Certificate of Appropriateness BAR #25-0074 712 Ridge Street, TMP 250067000 Ridge Street ADC District Owner: Chinh Le & Vanita Gupta

Applicant: Chinh Le Project: Driveway

City of Charlottesville Board of Architectural Review Staff Report April 15, 2025

Ridge Street ADC District Owner/Applicant: Chinh Le Project: Construct driveway

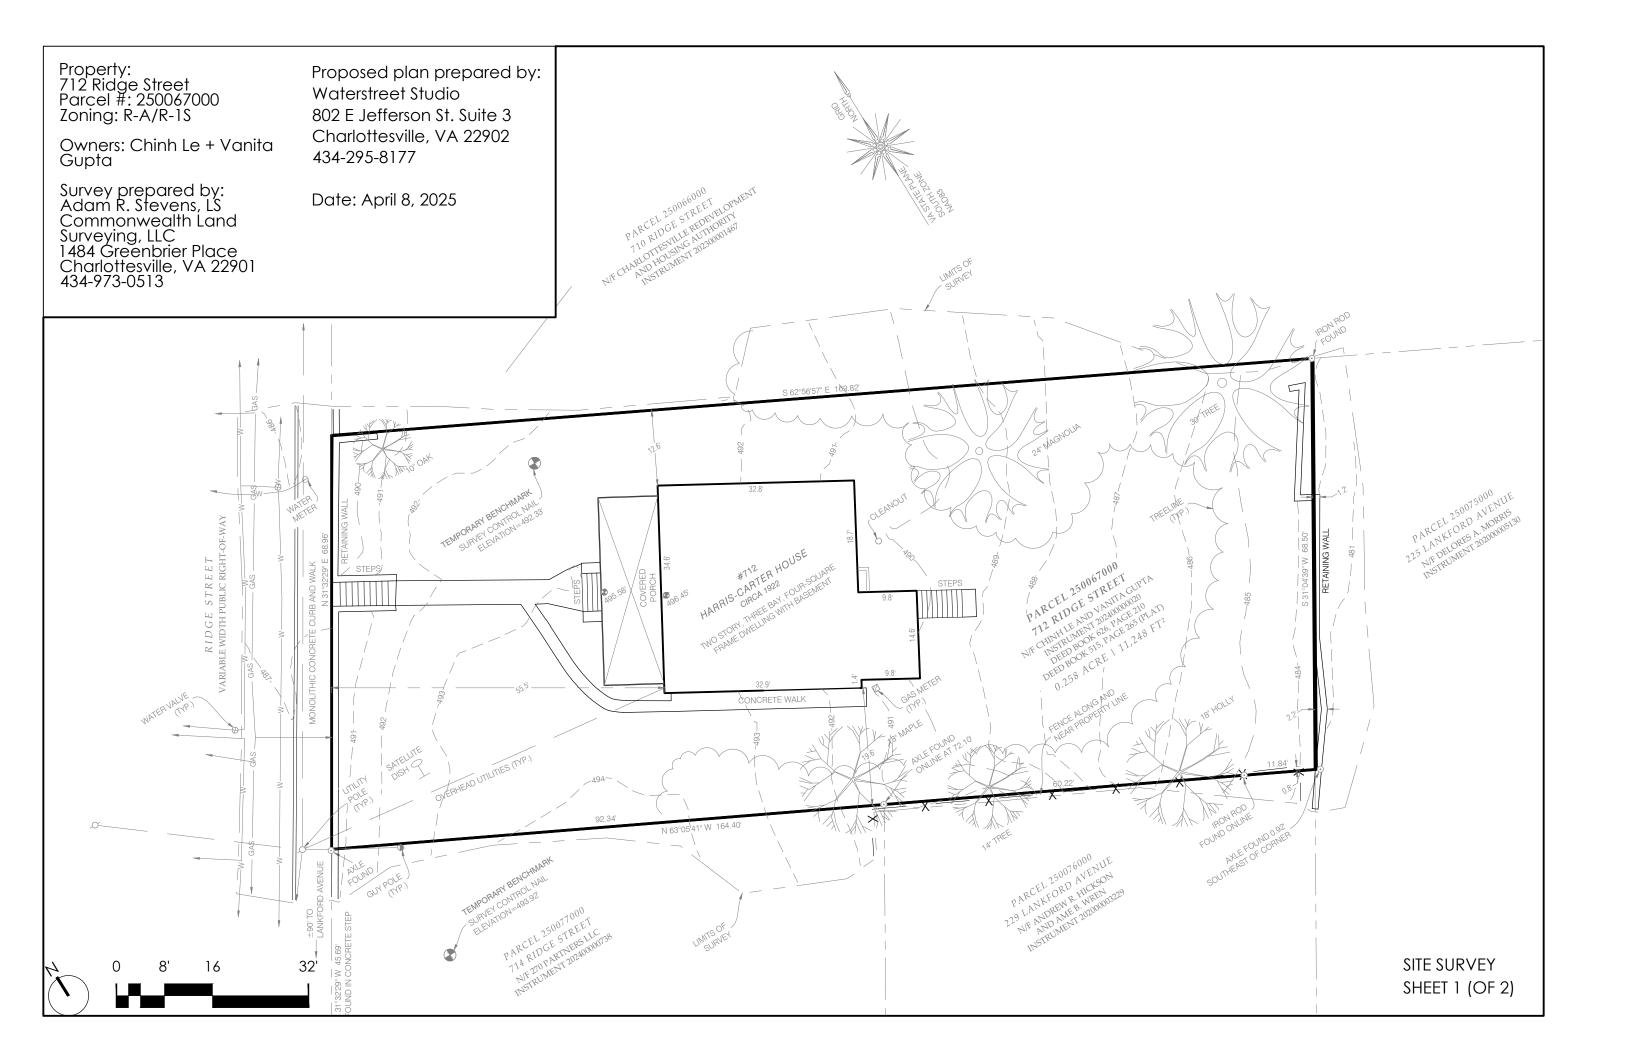
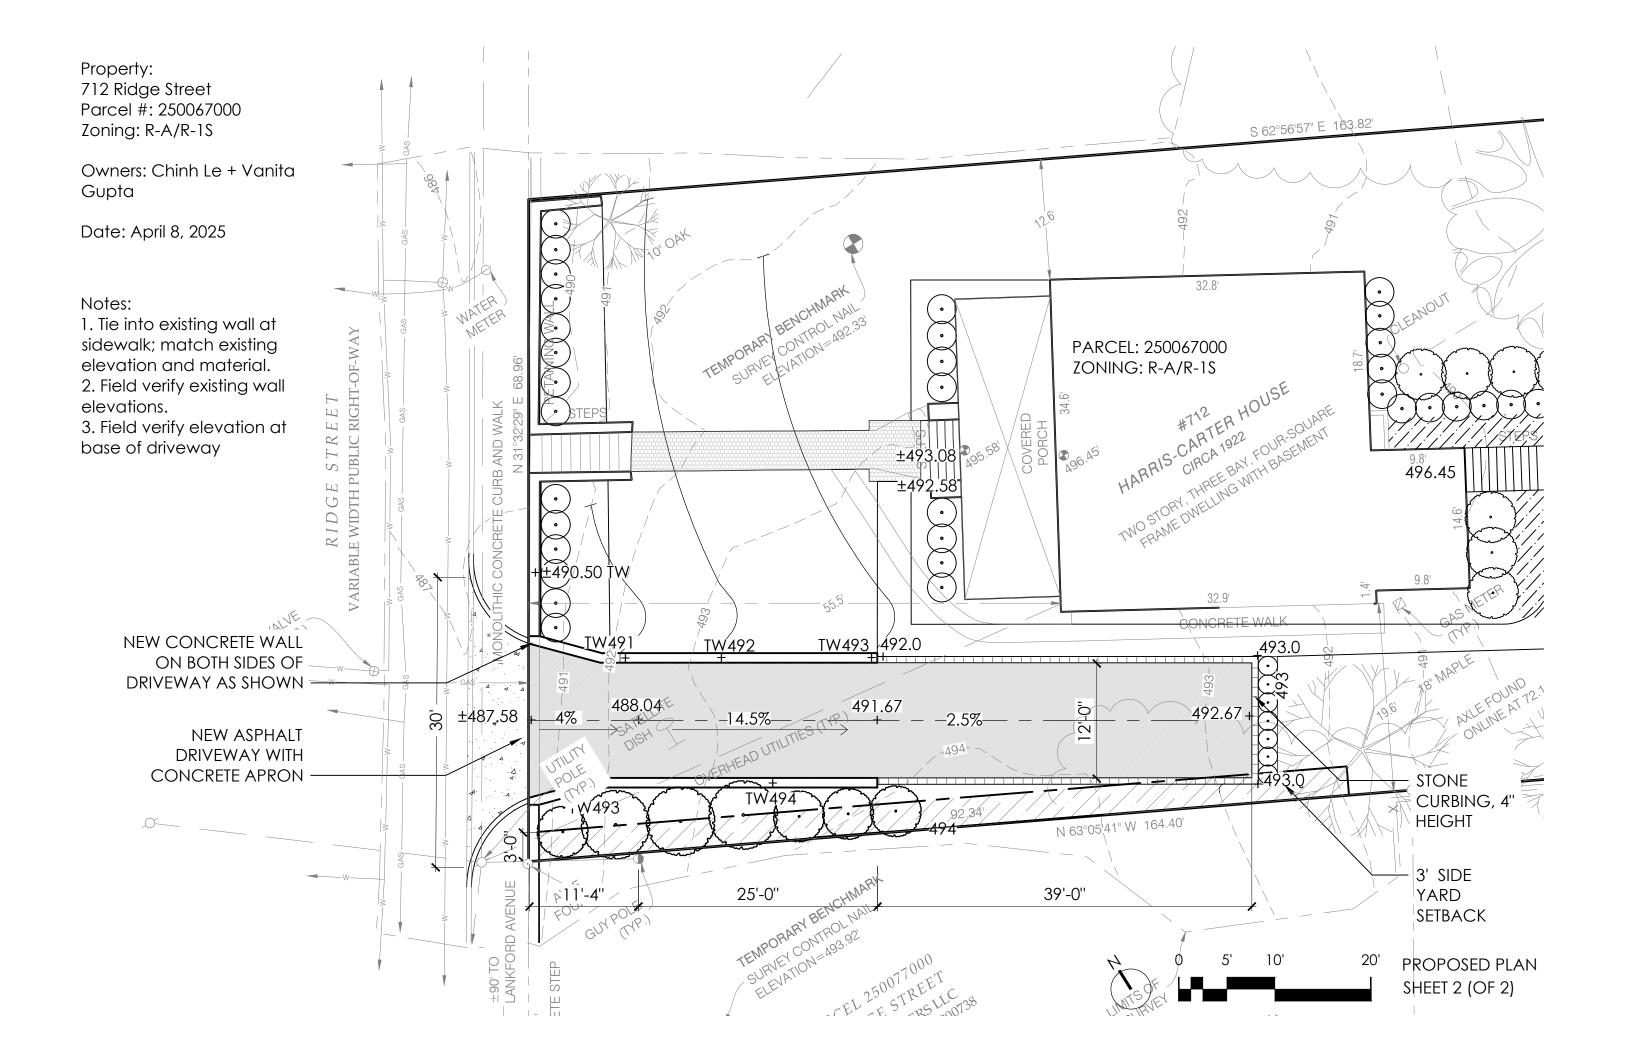
This project would entail puncturing the existing concrete retaining wall running along the Ridge Street property boundary to provide off-road access to the residence. New concrete

retaining walls will wrap into the site along both sides of the new asphalt drive. The new concrete retaining walls would match the height, material, and character of the existing walls at the street, and taper or step down to meet grade. A cobble curb would wrap the edges of the asphalt drive and provide a clean edge and transition between materials. Other proposed site improvements include re-grading the front portion of the property to ease the overall slope and to meet newly proposed top of wall grades at the driveway, as shown in plan. The existing front concrete walkway may also be updated and replaced with natural stone material including a new stone landing at the front porch. Secondary pathways on the site will be stone dust or pea gravel material with steel edging.

Staff recommends approval. Staff reviewed with zoning and engineering, and there are no issues with allowing wall breach and driveway.

The proposed driveway will be asphalt, with a concrete apron at the sidewalk and curb. The property is within Sub-are A of the Ridge Street ADC District. Five of the 16 properties in this sub-area have driveways. Of those, four are asphalt.

Additionally, at Staff's request, the applicant extended the driveway (approx. 20-ft) into the side yard. To extend it further toward the rear would disturb the dripline of the existing maple (18" dbh).

ILLUSTRATIVE SECTION (FOR CLIENT USE ONLY)

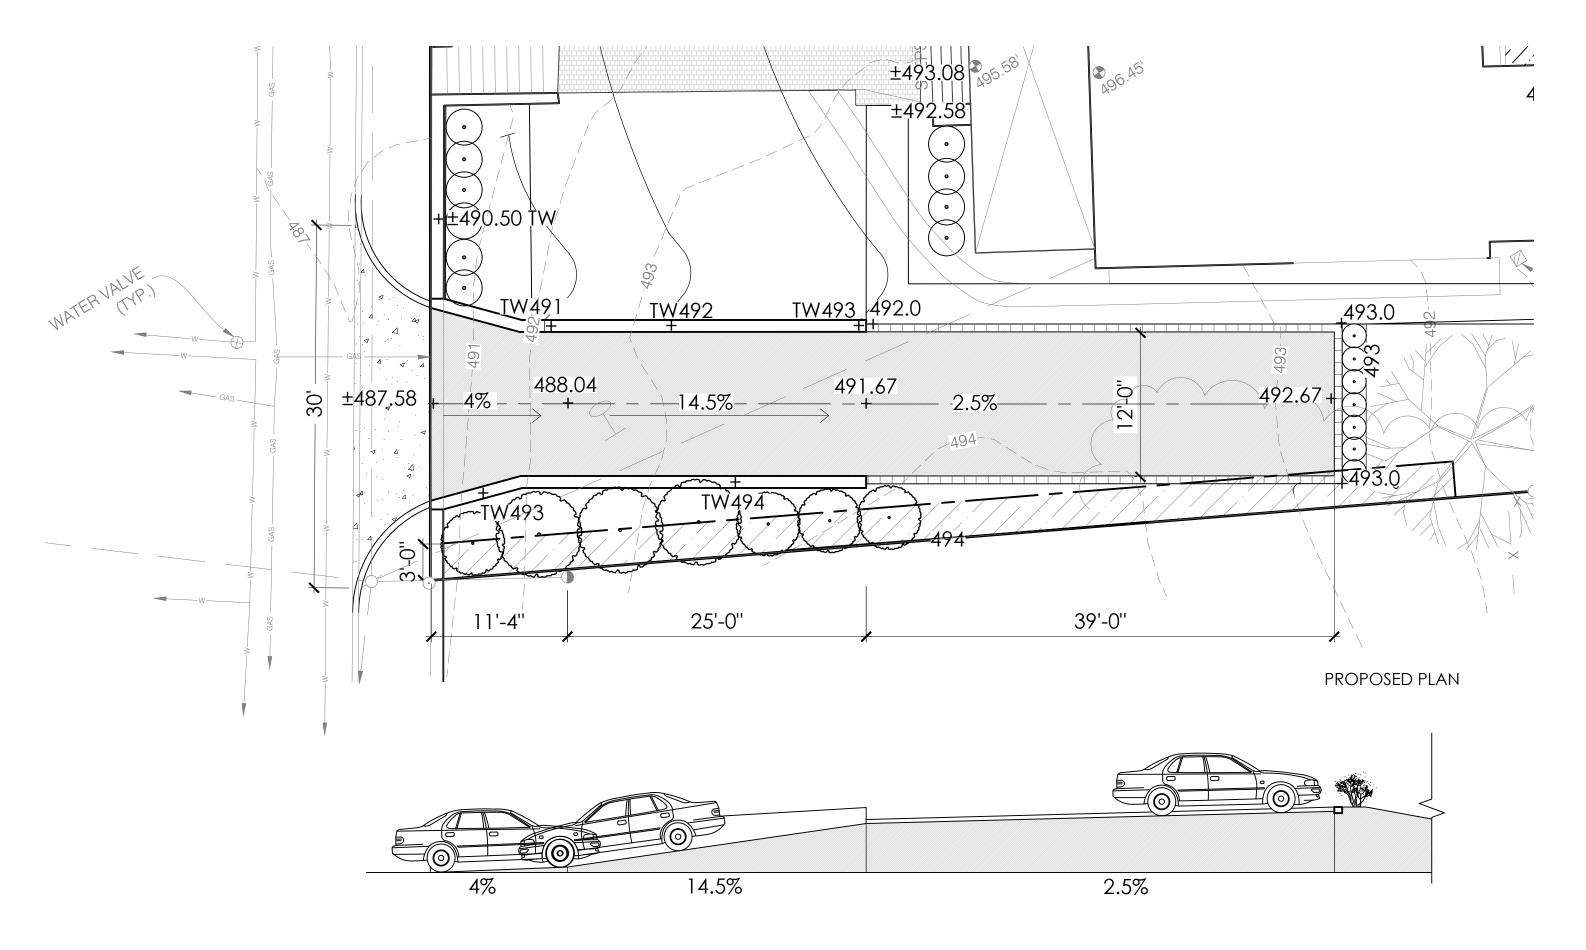
Mr. Zehmer – I would like to see a site plan with details regarding the retaining wall.

Mr. Birle – The retaining wall is pretty character defining.
